D4842-1
Job Sheet 169630

Part Name: Lower Cutter Deflector

D4842-041 LOWER CUTTER ASSEMBLY

From: William Monterroza
Sent: Monday, January 08, 2018 1:22 PM
To: Support San Diego; Kim Johnston; Caitlin Crooks
Cc: Linda Lacelle; Mario Poulin; Maria Scatola; Diane Baker
Subject: RE: New Order n° 4801493469

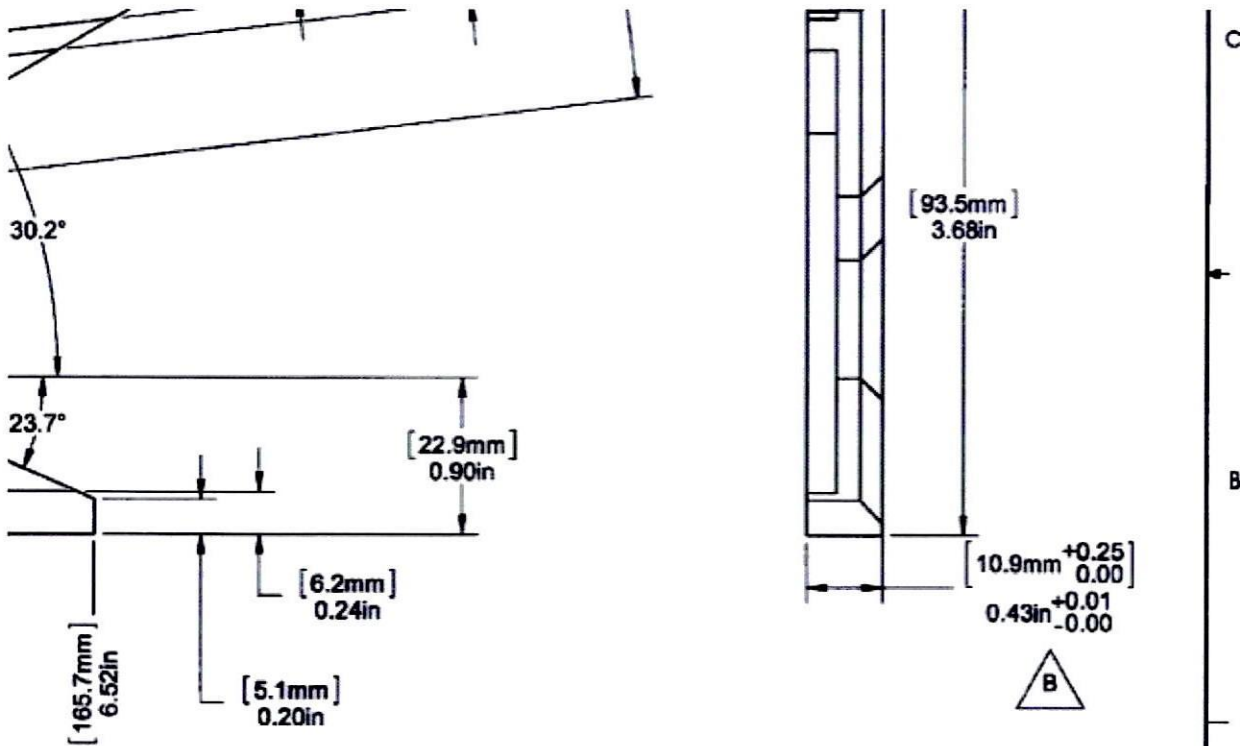
I am available for call, but I think, if I am wrong, the problem has been generated with the rev. B of the lower cutter, see sketch below, where the tolerance had been increased, in my opinion DART can adjust the tolerances in order to not have the problem.
